Product Change Notification

Date Issued :	April 06, 2023	PCN Number :	513150
Reason for Change :	Equipment Transfer, Production Transfer or Rearrangement		
Description of Change :	This notification is to inform about Production of the impacted part(s) in this PCN has been transferred to different location. No changes will be made to product as part of this change.		
Assessment of Change :	First Article Inspection		
Planned Implementation Date :	October 10, 2023		
Sample Availability Date:	June 15, 2023		
Internal Molex Qualification Date :	June 18, 2023		
Last date to request Samples by Customer :	June 30, 2023		
Traceability Code Markings / Date :	Product made after planned implementation date can contain the change

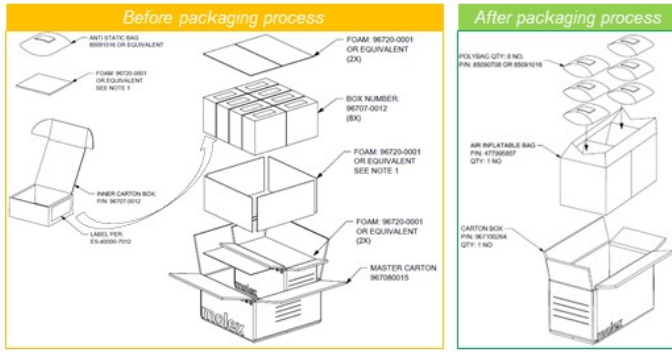
- This specific PCN covers the transfer of automated assembly machines, supporting component tooling and auxiliary equipment”
- To facilitate a smooth transfer, we will build buffer stock as needed. (1) **We also will locally source packaging materials DU & MLQ will change accordingly.** (2) Raw materials source change (3) Additional machinery / tooling if required

DU & MLQ Change:

- 1) All 6410series parts running in 8204 plant are with Air Inflatable bag packaging.
- 2) Packaging method will be changed for these 9 parts as well.
- 3) There will be change in DU & MLQ qty.
- 4) New packaging change was validated with drop test at 80cm drop height for similar parts.
